Central Valley Regional Water Quality Control Board

ORDER AMENDING CLEAN WATER ACT SECTION 401 WATER QUALITY CERTIFICATION AND ORDER; HONEY RUN COVERED BRIDGE ASSOCIATION, HONEY RUN COVERED BRIDGE REPLACEMENT PROJECT (WDID NO. 5A04CR00312A1), BUTTE COUNTY

AMENDMENT:

Figure 3. Honey Run Covered Bridge Replacement Project Impacts to Waters of the United States.

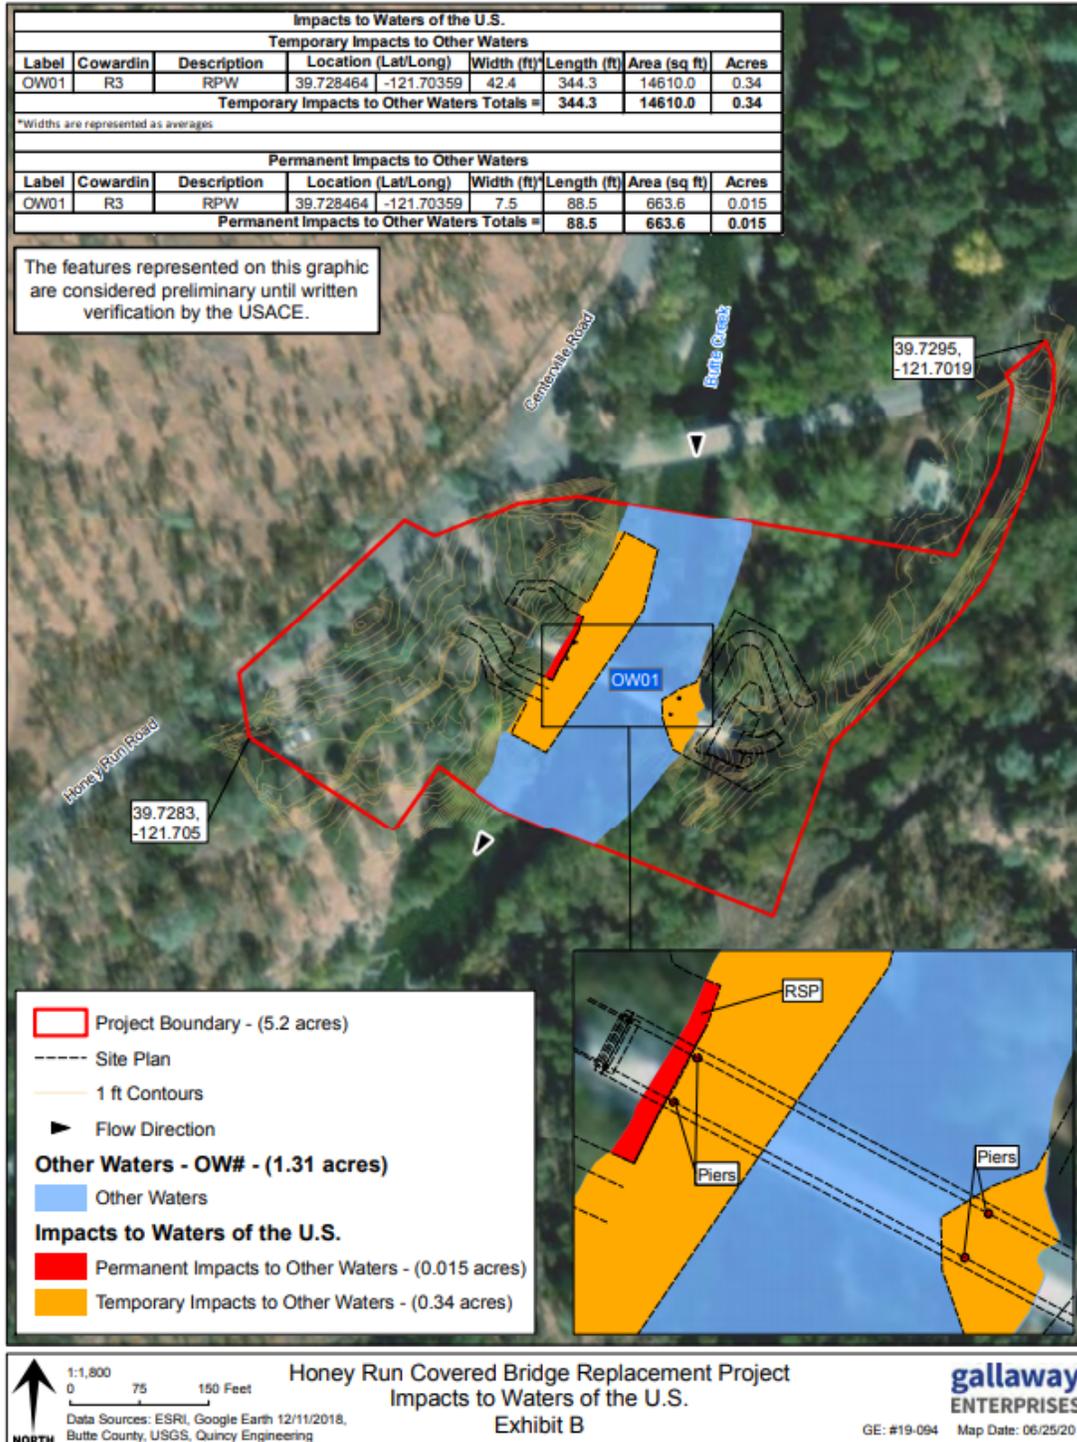
Honey Run Covered Bridge Association is requesting an amendment to the Section 401 Water Quality Certification and Order to modify the column size of the bridge, resulting in an increase of 0.005 acre of permanent impacts. Therefore, Section IV; Section VII, Table 2; Attachment A, Figure 3; and Attachment B, Table 3 are amended in underline format below.

The selected foundation system is combination of spread footings bearing on dense soils at the abutments and a deep foundation pile system for the intermediate piers consisting of [48-inch](#) diameter cast-in-drilled-hole (CIDH) piles. All foundations will extend into competent soil materials beyond their respective scour depths. Construction of these foundations will require earthwork excavation and backfill on both the terrace banks and in the streambed. It is anticipated that temporary shoring systems may be required to allow placement of the abutment reinforced concrete spread footings. Installation of the intermediate pier CIDH piles will require the use of at least two cranes, a drilling auger, and drilling techniques involving drilling slurry fluid. It is anticipated that full length drilling casings may be used to keep the drilled holes open from caving prior to placement of bar reinforcement and pile concrete. Two CIDH piles will be installed at each intermediate pier for a total of four [48-inch](#) diameter CIDH piles. The CIDH piles will be extended above ground to serve as column extension supports at each pier location.

Aquatic Resources Type	Acres	Cubic Yards	Linear Feet
Stream Channel	<u>0.015</u>	<u>92.6</u>	88
